Access Compliance Report

Public Rights-of-Way

(Curb Ramps)

Intersection ID: 20476	Main Street: SHADOWCREST_DR	Cross Street: WOODKNOLL_DR	Location: W
ADA ID: ED5B37B7E27D	Ramp Type: Perp	Initial Pass/Fail: Fail	Overall Compliance: No
Severity Score: 12.5			
Codes/Mitigation Info/Possible Solution		Field Measurements/Component Compliance

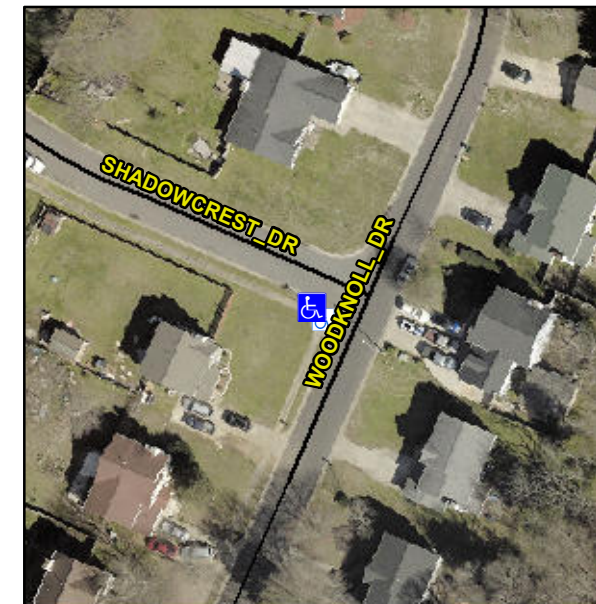
R304.2.2

Compliance	Description	Data	Compliance	Description	Data
N/A	Ramp Length (in)	95.0	No	Ramp Slope (%)	9.6
Yes	Ramp Width (in)	57.0	Yes	Ramp XSlope (%)	0.7
N/A	Flare Type LT	N/A	N/A	Flare Type RT	N/A
N/A	Flare Slope LT (%)	N/A	N/A	Flare Slope RT (%)	N/A
N/A	Flare Traversable LT?	N/A	N/A	Flare Traversable RT?	N/A
N/A	Landing Length (in)	N/A	N/A	DWS Provided?	N/A
N/A	Landing Width (in)	N/A	N/A	DWS Contrast?	N/A
N/A	Landing Slope (%)	N/A	N/A	DWS Length (in)	N/A
N/A	Landing X Slope (%)	N/A	N/A	DWS Full Width?	N/A
N/A	Landing Curb? (Y/N)	N/A	N/A	DWS Offset (in)	N/A
N/A	Shared Landing?	N/A			
N/A	Gutter Ponding?	N/A	N/A	Gutter Slope (%)	N/A
N/A	Gutter Lip Ht (in)	N/A	N/A	Gutter X Slope (%)	N/A
N/A	Painted X Walk1?	No	N/A	Painted X Walk2?	N/A
	X Walk 1 Direction	To NE		X Walk 2 Direction	N/A
N/A	X Walk 1 Width (in)	N/A	N/A	X Walk 2 Width (in)	N/A
	X Walk 1 Slope (%)	0.6		X Walk 2 Slope (%)	N/A
	X Walk 1 X Slope (%)	2.1		X Walk 2 X Slope (%)	N/A

Remove & Replace Entire Ramp.
